Mussetter Engineering Inc.

Memorandum

Project: 04-31

Subject: DRAFT Comments for Design Features. Main Branch Calabacillas Arroyo

Figure 3. Computed average annual aggradation/degradation depths for existing conditions (existing hydrology), existing conditions (future hydrology), design conditions at existing grade (future hydrology), and design conditions at the equilibrium slope (future hydrology).

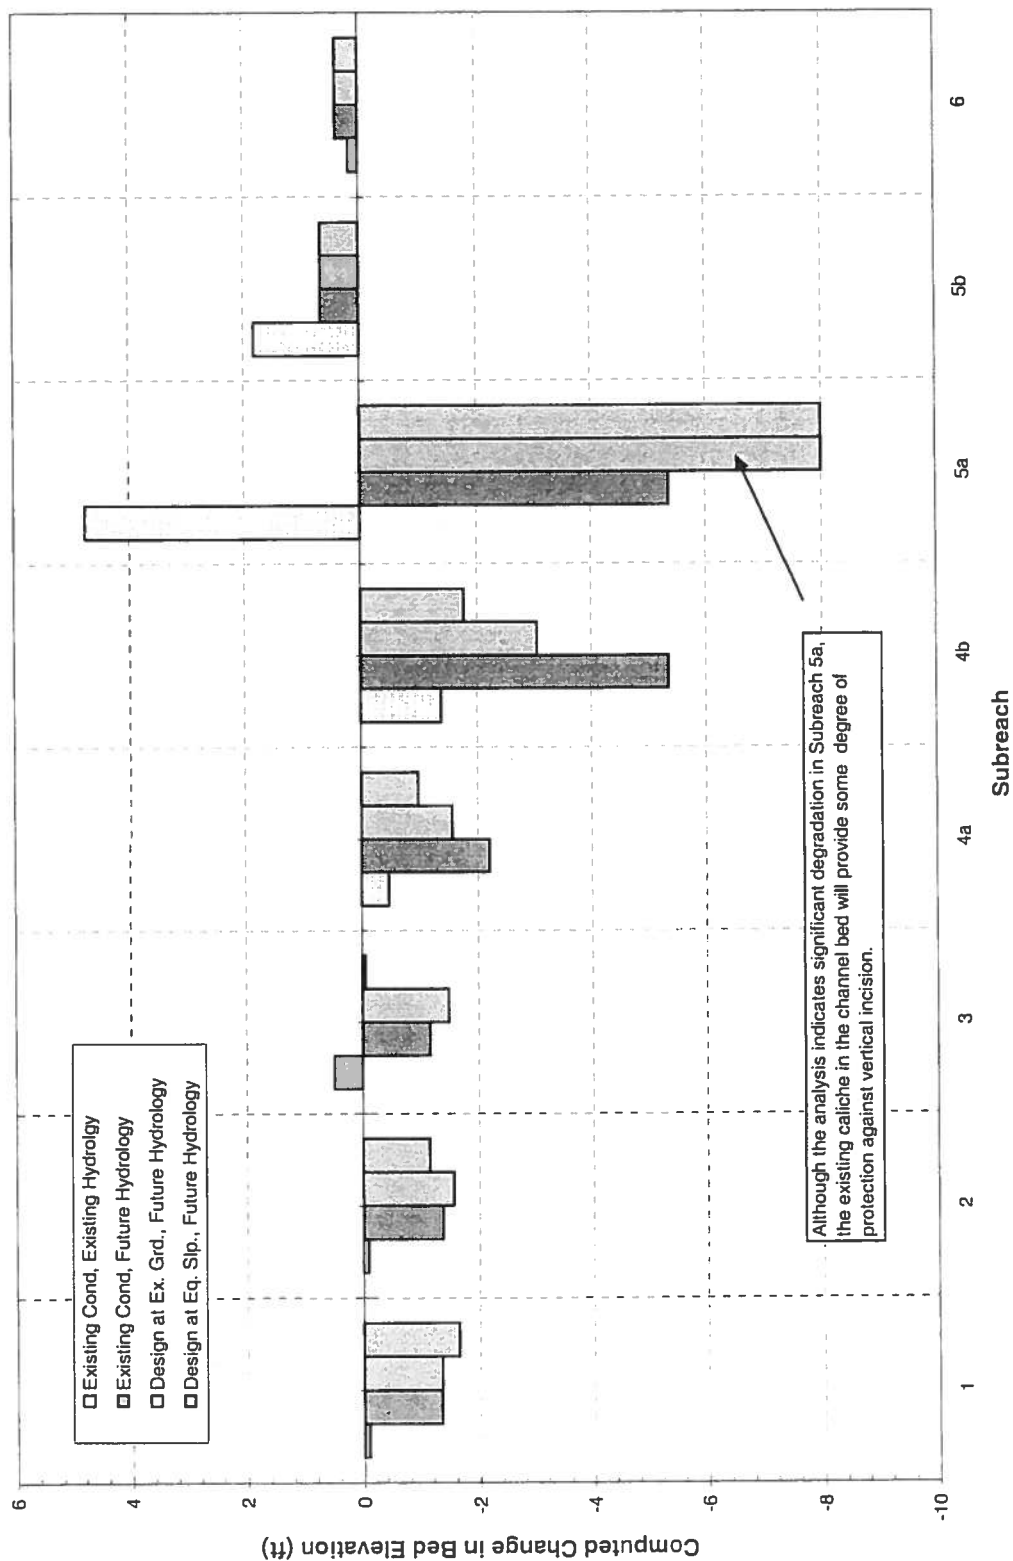
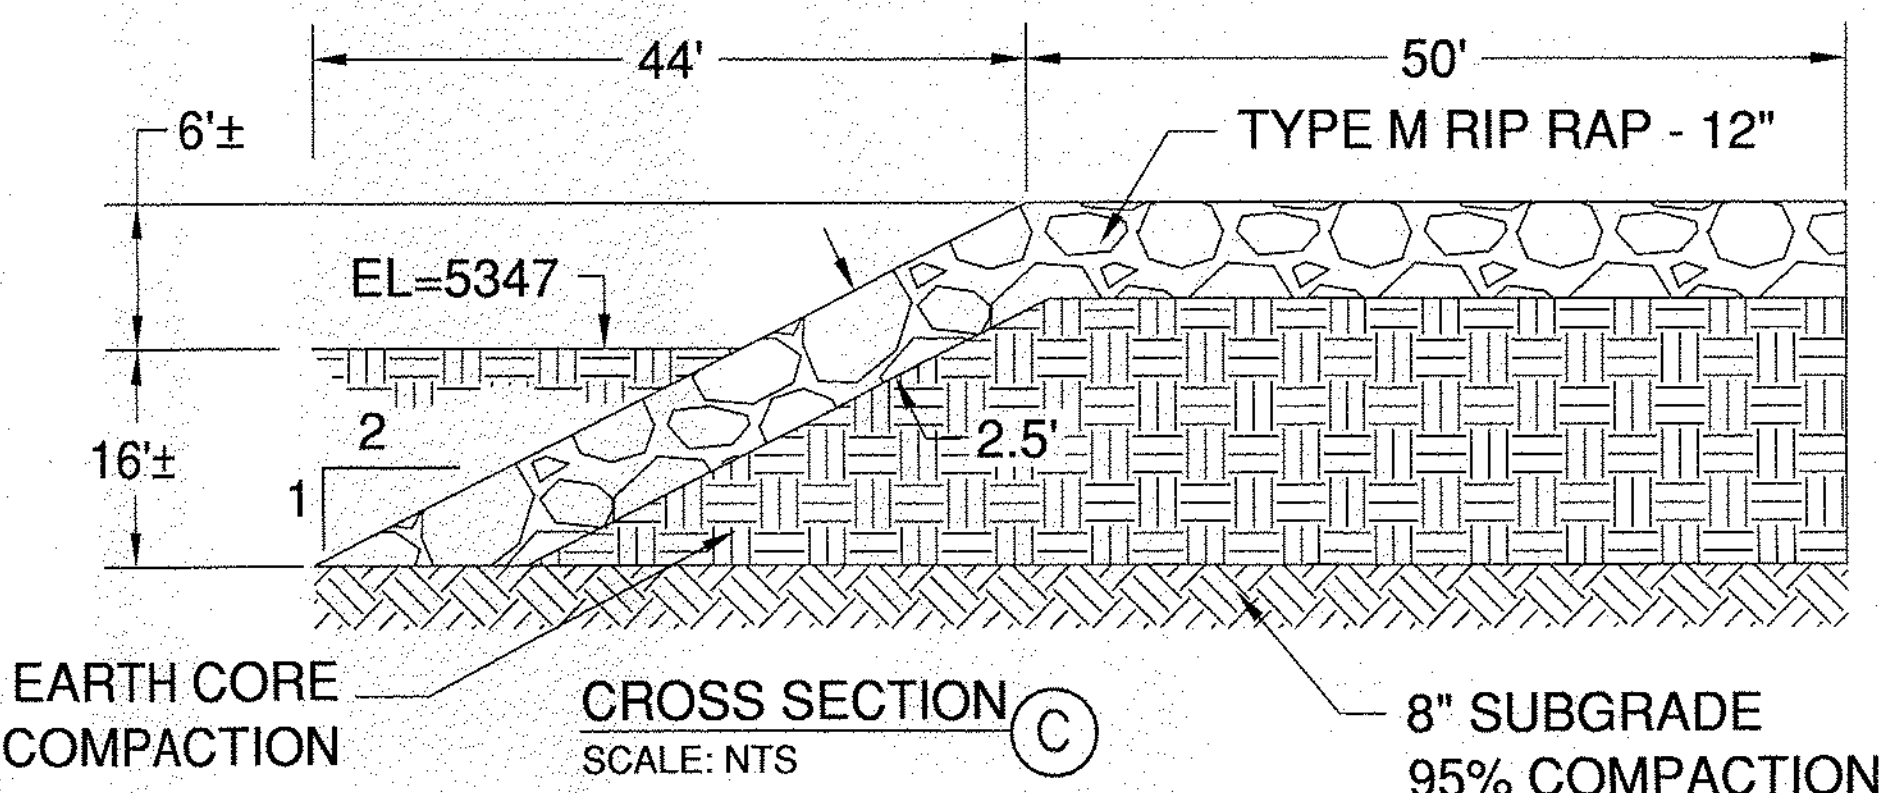
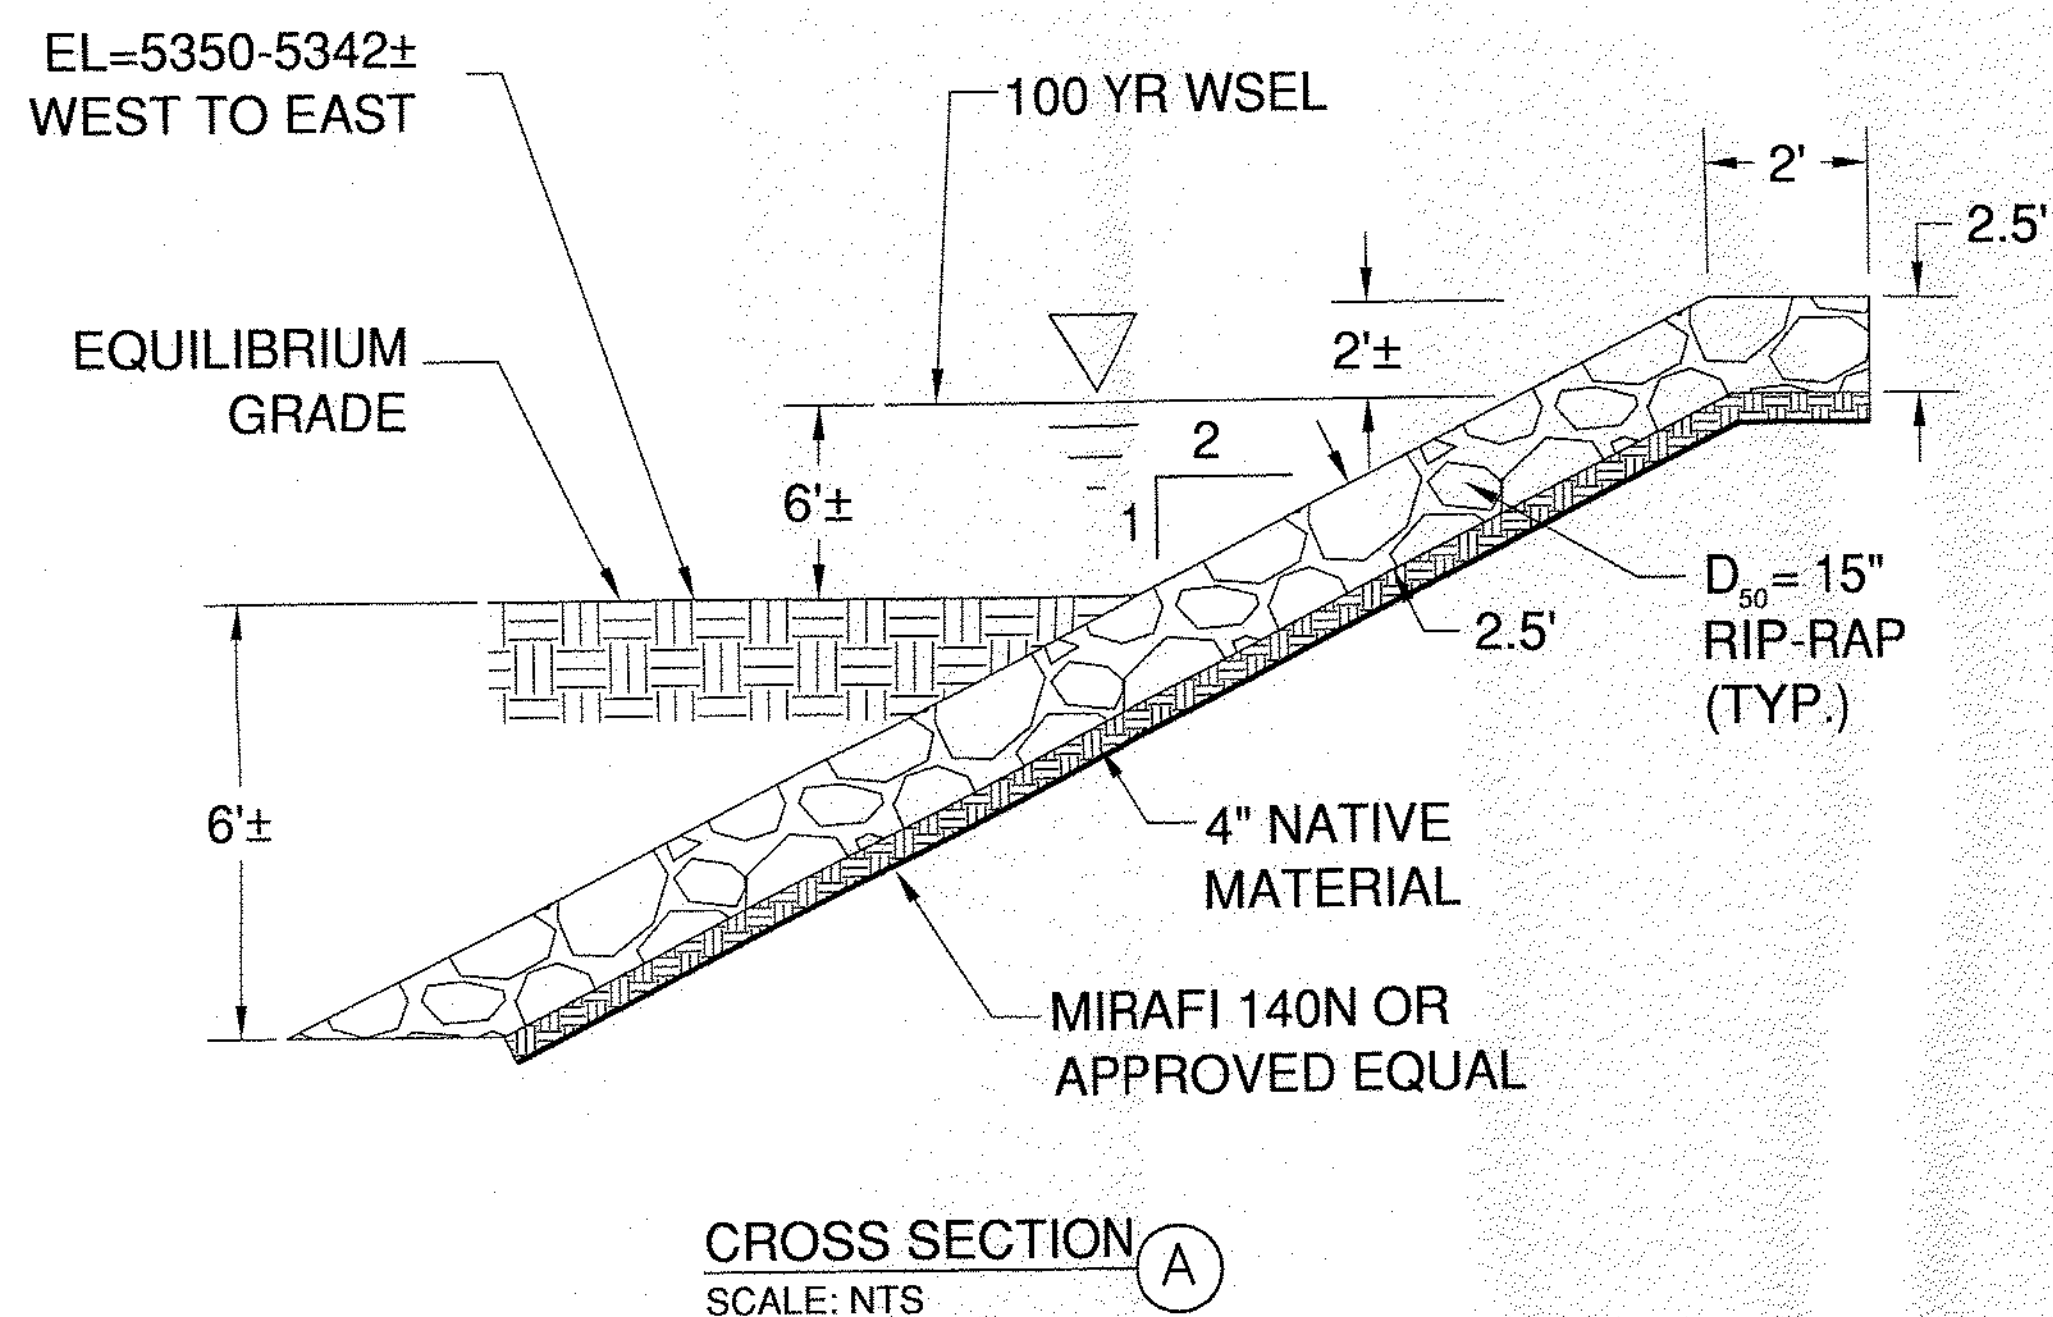
The computed aggradation/degradation volumes from the sediment-continuity analysis were converted to average aggradation/degradation depths by dividing the volumes by the subreach length and width (**Figure 3**). It should be noted that the sediment-continuity analysis results for Scenario A (existing conditions and existing hydrology) represents a short-term scenario, where the sediment supply to any given reach was derived from both tributaries and the supply from the next upstream subreach. The results for the future conditions hydrology scenarios (Conditions B, C, and D) represent a long-term scenario, where the transport capacity for a given subreach was compared to the upstream supply to the overall project reach and local tributaries. This comparison effectively assumes that the capacity of the channel throughout the project reach has adjusted to the upstream supply to the overall reach. The results indicate that under existing topographic conditions and existing hydrology, the system is essentially in balance except for the subreach in Swinburne Pool (Subreach 5b), which is aggradational. Under the existing topographic conditions and future hydrology, the system is degradational throughout the project reach (Subreaches 2 through 5a), with Subreaches 4b and 5a being the most strongly degradational. Under the design conditions at existing channel grade with future hydrology, slightly more degradation than under existing conditions is indicated in Subreaches 2 and 3, less degradation is indicated in Subreaches 4a and 4b, and significantly more degradation is indicated in Subreach 5a. Under the design scenario at equilibrium slope with future conditions hydrology, the analysis indicates that the degradation is significantly reduced in all subreaches except Subreach 5a. The bed in this subreach has a considerable amount of erosion-resistant caliche, and it has been assumed that the caliche will provide grade control that will prevent significant degradation. It is important to note, however, that caliche is not non-erodible, and degradation could occur in this area over the long-term. The thickness of the caliche layer is also not known. If it is relatively thin, erosion through the caliche could cause rapid degradation in this reach. While MEI is comfortable with the assumptions that have been made to date on this issue, we strongly recommend that this area be monitored very carefully in the future, and corrective actions, including additional grade control constructed, if warranted. It should be noted that the overall degradational tendencies under the

equilibrium slope conditions is a likely somewhat conservative, at least over a short- to medium-term time-frame, because it assumes that the entire upstream channel, including reaches upstream from the county line have adjusted to the watershed sediment supply associated with the assumed 2038 development conditions. During the period when the upstream channel is adjusting to development, the sediment load will be substantially higher than the supply 2038 conditions over the long term. In fact, depending on the spatial distribution of the development as it occurs, the short- to medium term sediment yields may actually be higher than the existing supply.
